**ADDENDUM NUMBER 4**Project Number: **STP 3400 (438) and 89002847**Project Title: **Blue River Trail: Brush Creek to Stadium Dr (Segment B)**ISSUE DATE: **May 15, 2018**

Bidders are hereby notified that the Bidding and Contract Documents for the above project, for which Bids are to be received on **Tuesday, May 22, 2018 at 2:00pm**, are amended as follows:

# B212

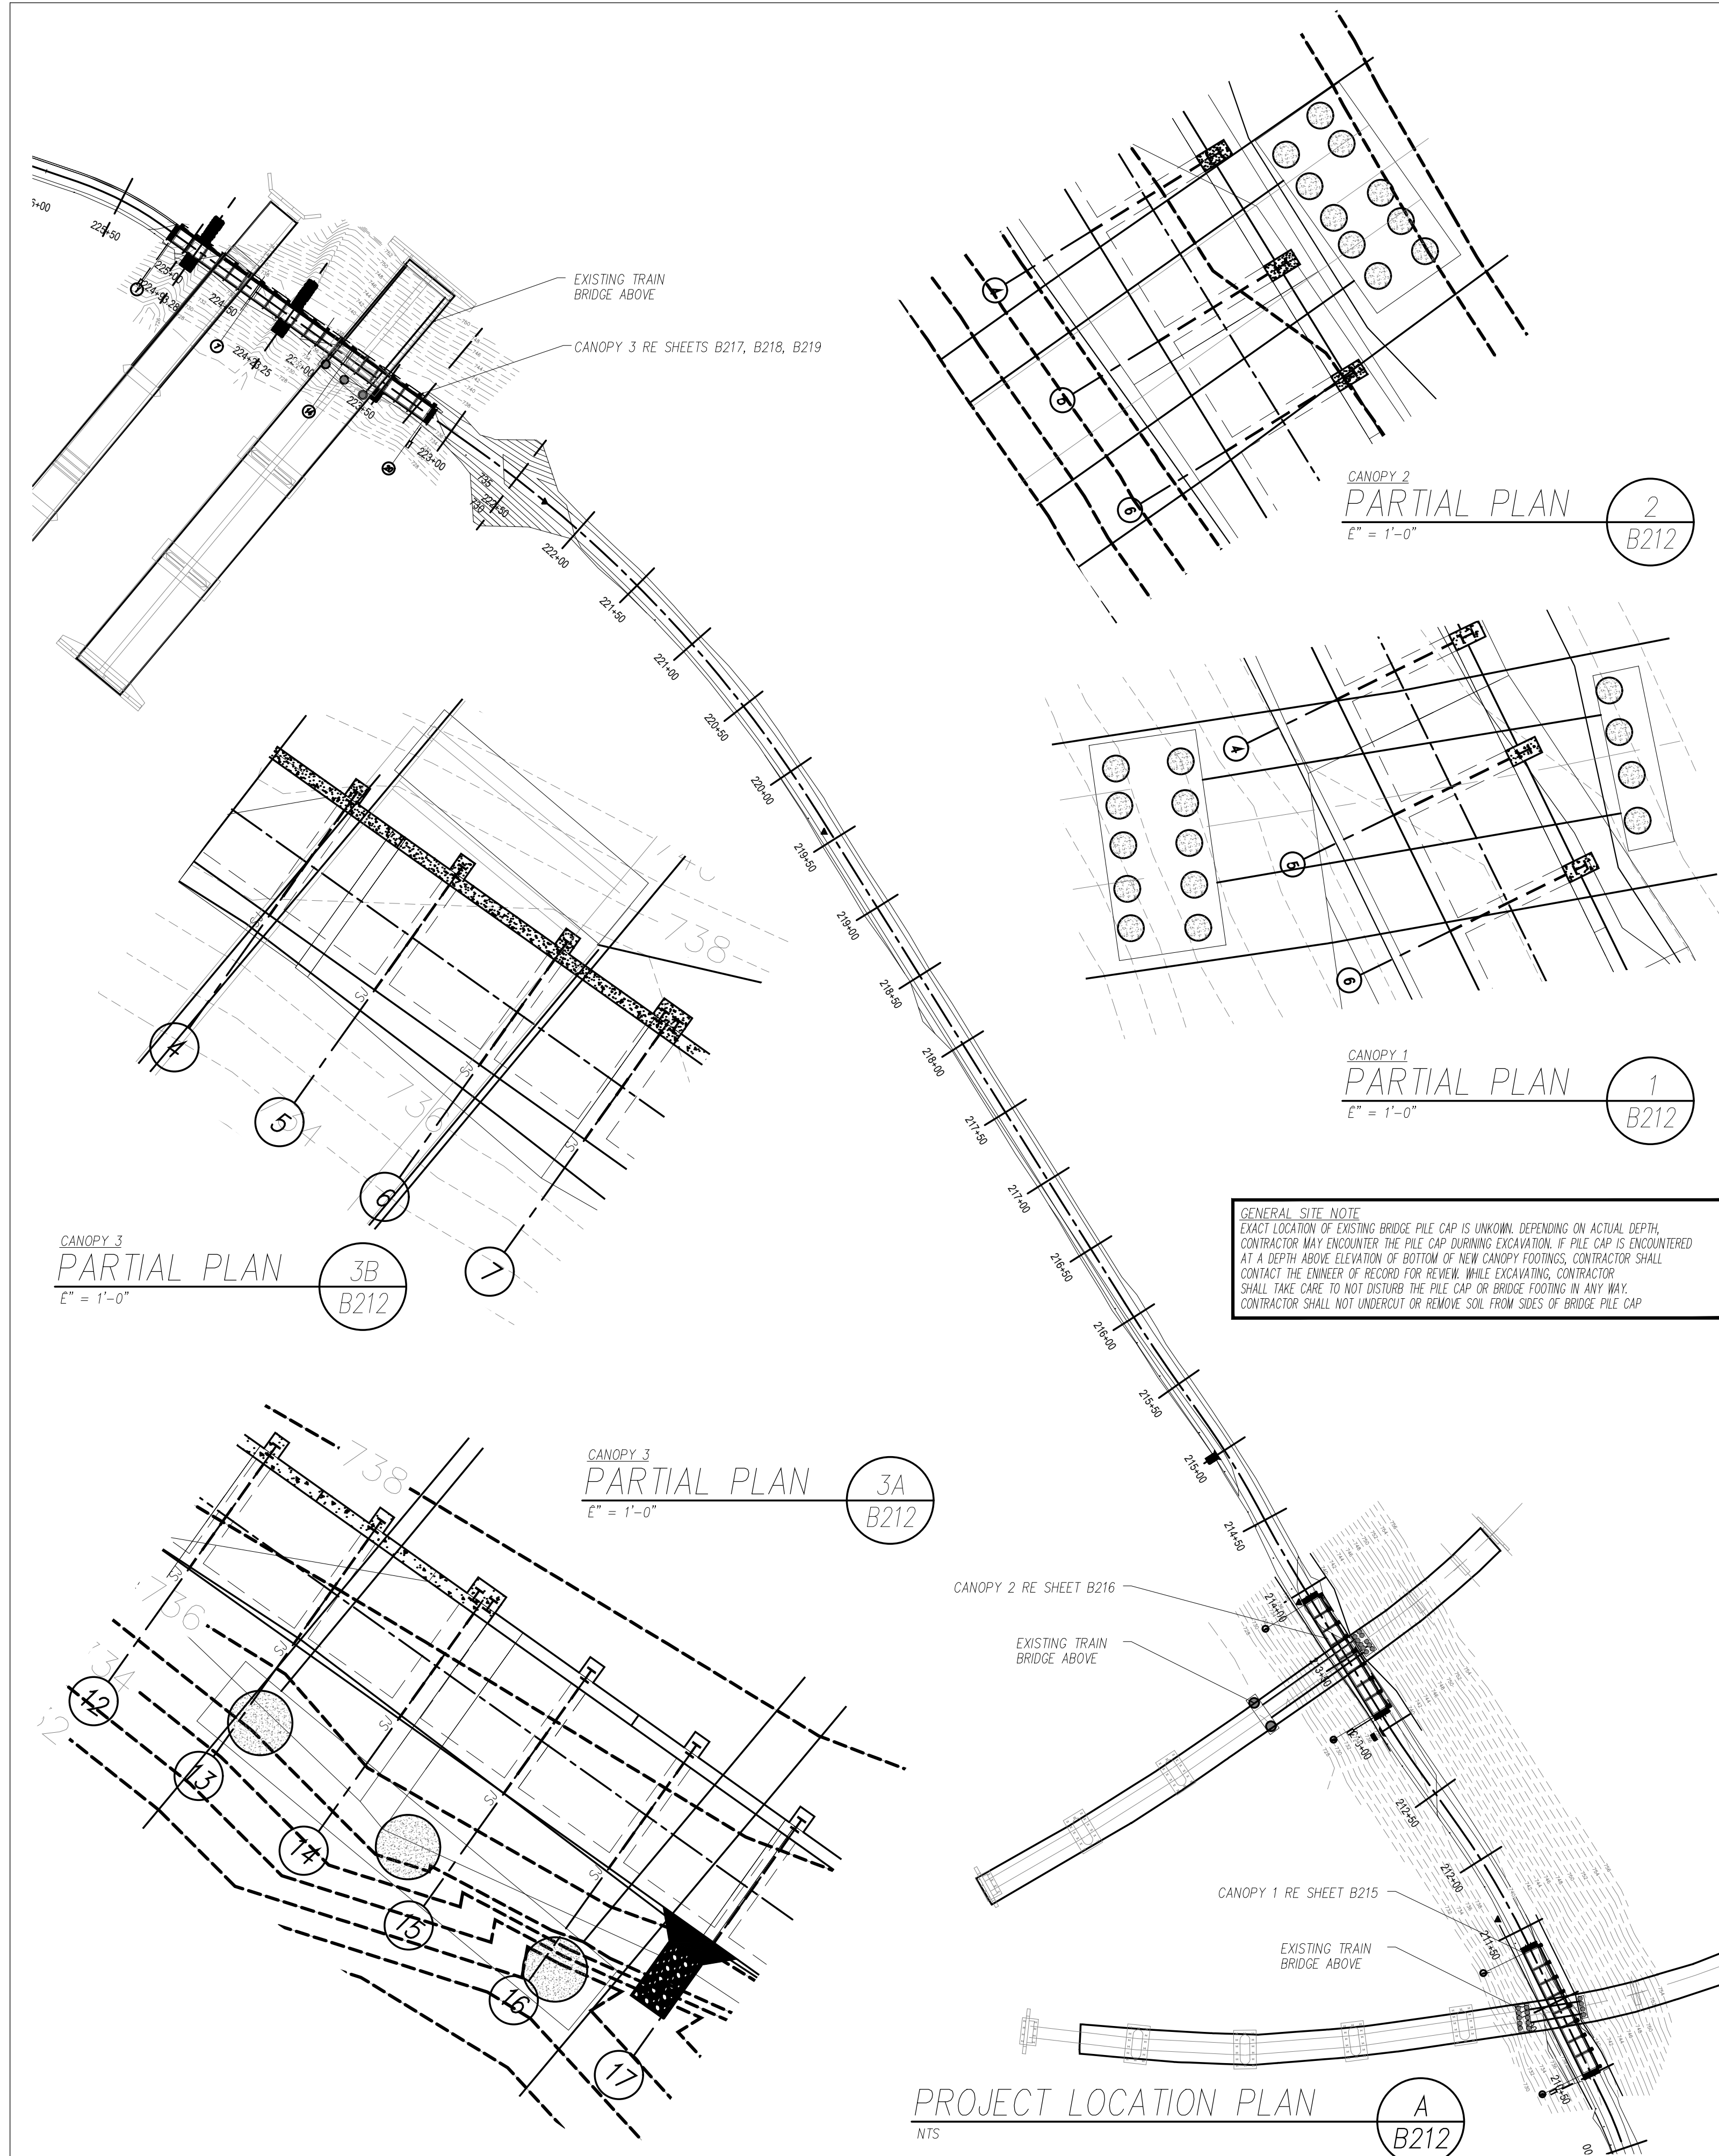
A17.	<b>This subsidence is related to recent utility work in the area and is likely the result of improperly compacted backfill. It is expected that the Contractor will provide fill material and proper compaction as needed in the area of the trail to meet design intent/provide proper drainage.</b>
Q18.	There is conflicting information regarding the steel material for the canopy structures. Section 05500 Metal Fabrication 2.3.A calls for Steel Plates, Shapes, and Bars as ASTM A36. On plan sheet B212, Structural Notes 7.C.1 calls for Shapes W, C, MC, T to be A588 Gr 50 Weathering Steel and 7.C.3 calls for Plates to be A36. Then 7.H calls for non-weathering to be galvanized. Galvanized plates can't be welded to weathering steel beams as shown on detail BPI/B213. Please clarify.
A18.	<b>Specification Section 05500 Metal Fabrications does not apply to the canopy structures. Specifications for the canopy structures can be found on Sheet B212. Please refer to revised Sheet B212 for revisions to structural notes.</b>

8. **Delete** Sheet B212, **Replace** with attached Sheet B212 (Revised 2018-04-26.)
9. Sheet B300, Detail 03-Concrete Pavement: **Replace** "6" WWF Reinforced [...]" with "6" micro-fiber reinforced [...]"

# EXHIBIT A

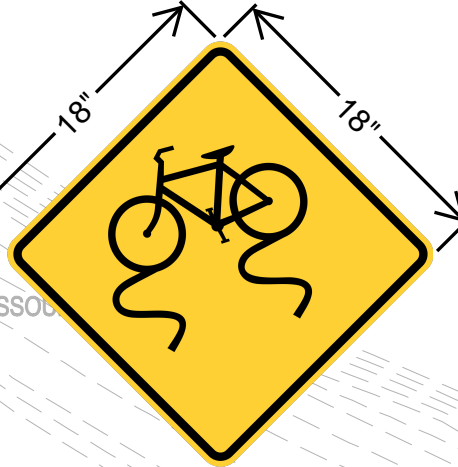
1. Sheet B002: **Revise** quantity and unit for L.I.#12, Soil Stabilization to 1,600 CY.
2. Sheet B002: **Revise** quantity for L.I.#25, Trail Signage to 13 EA. Refer to attached Exhibit A.

STA. 205+25.52  
OFFSET = 8.75R  
INSTALL 'SLOW' &  
'SHOULDERS DROP OFF'  
SIGNS (CUSTOM)

STA. 205+75.54  
OFFSET = 8.75R  
INSTALL BICYCLE SURFACE  
CONDITION SIGN &  
SLIPPERY WHEN WET  
PLAQUE, MUTCD  
W8-10 & W8-10P

STA. 207+69.67  
OFFSET = 8.75L  
INSTALL BICYCLE SURFACE  
CONDITION SIGN &  
SLIPPERY WHEN WET  
PLAQUE, MUTCD  
W8-10 & W8-10P

STA. 208+19.85  
OFFSET = 8.75L  
INSTALL 'SLOW' &  
'SHOULDERS DROP OFF'  
SIGNS (CUSTOM)

# EXHIBIT B - STAGING AREAS

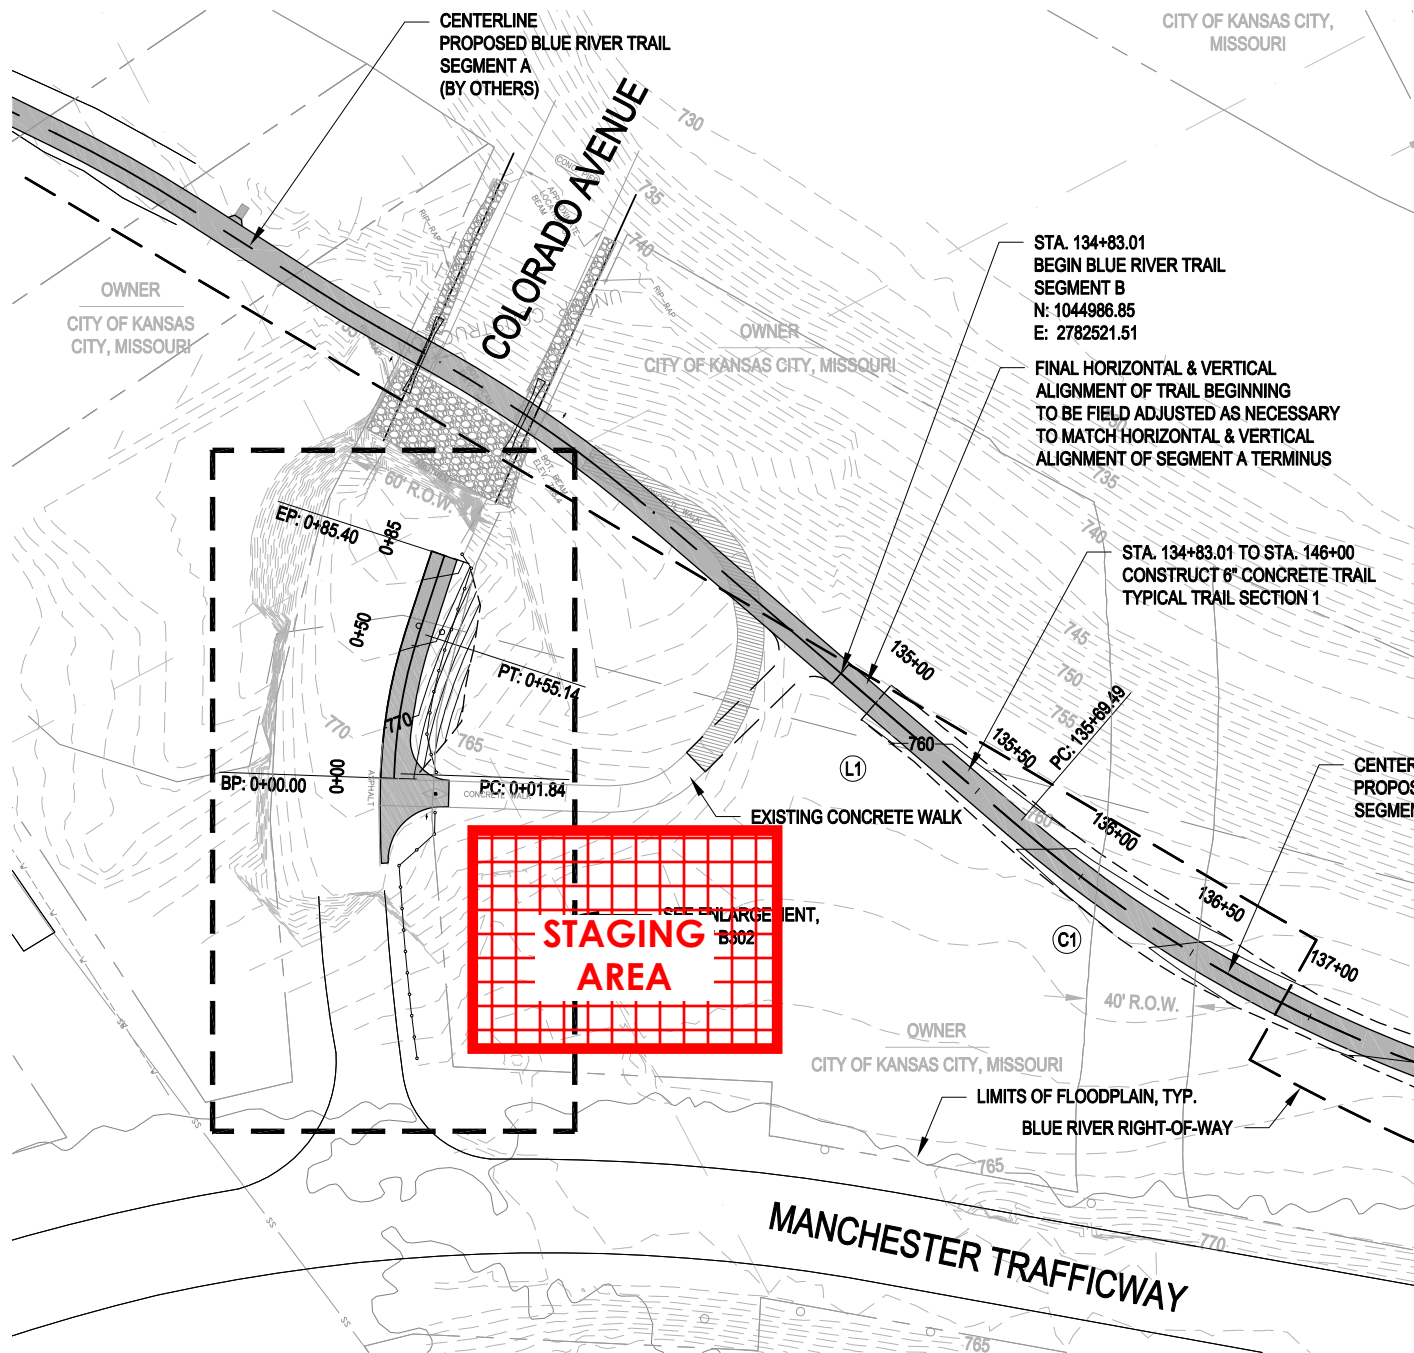
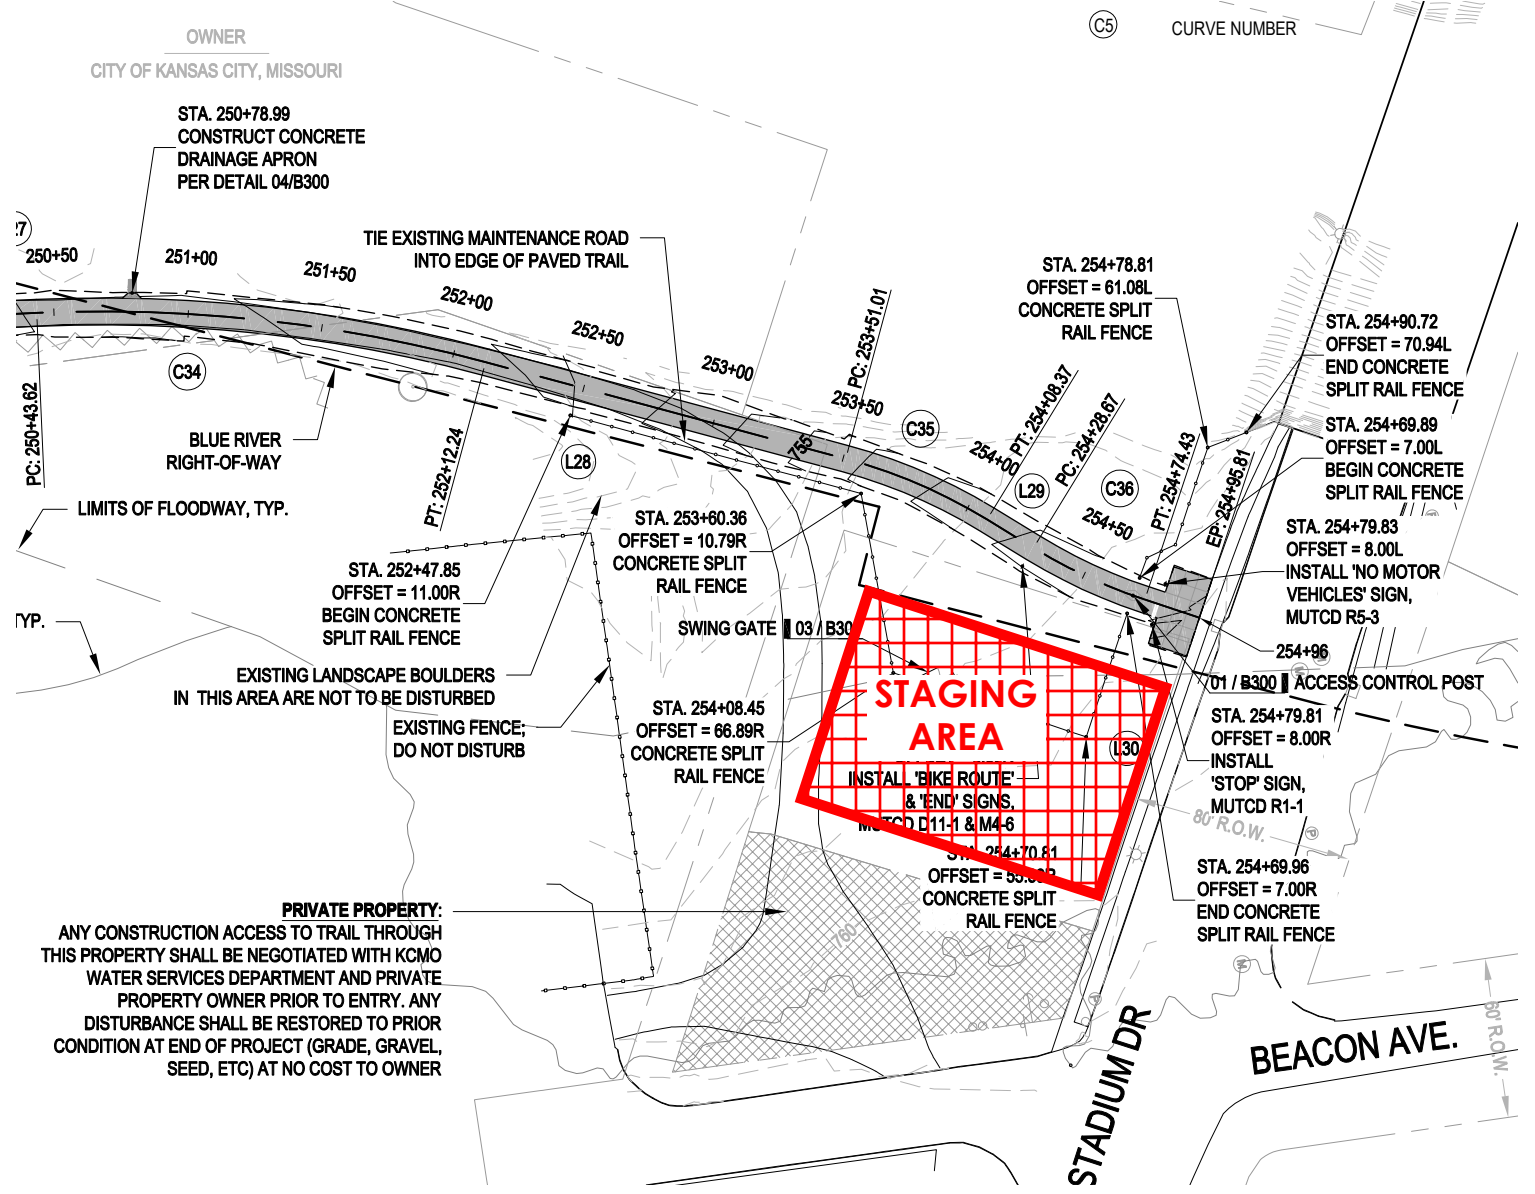
Q22.	Are there any ROW permits the contractor is required to get? If so, are these fees waived as noted in general conditions.
A22.	<b>None, that we know of, but there may be access easements required on railroad property.</b>
Q23.	Topsoil Shoulder Fill—Can this be fill dirt from onsite? There is no specification.
A23.	<b>The quantity shown on the bid form is for hauled-in topsoil. It is assumed that there will be no suitable topsoil available on-site for use as topsoil shoulder fill. As noted in Specification Section 02100-Grading, topsoil shoulder fill material shall meet the requirements of APWA-KCMO Section 02100 Grading and Site preparation (See APWA-KCMO Section 2102.4 Topsoiling)</b>
Q24.	Are there any locations excess dirt and spoils material can be placed onsite?
A24.	<b>The design team has identified two (2) locations for construction staging activities, including the potential storage of dirt and spoils material as needed. These are (1) the northwest corner of Colorado Avenue and Manchester Trafficway (near the project beginning) and (2) the south side of Stadium Drive, immediately adjacent to the project end. Please note private property constraint with construction staging area at Stadium Drive, as noted on plan sheet B110-Plan &amp; Profile Sta 242+00—Sta. 254+95.81. Construction staging/material storage locations shall be confined to City of Kansas, Missouri property; and, any disturbed areas shall be restored to prior condition at conclusion of project (grade, gravel, seed, etc.) at no additional cost to owner. Please refer to Exhibit B.</b>
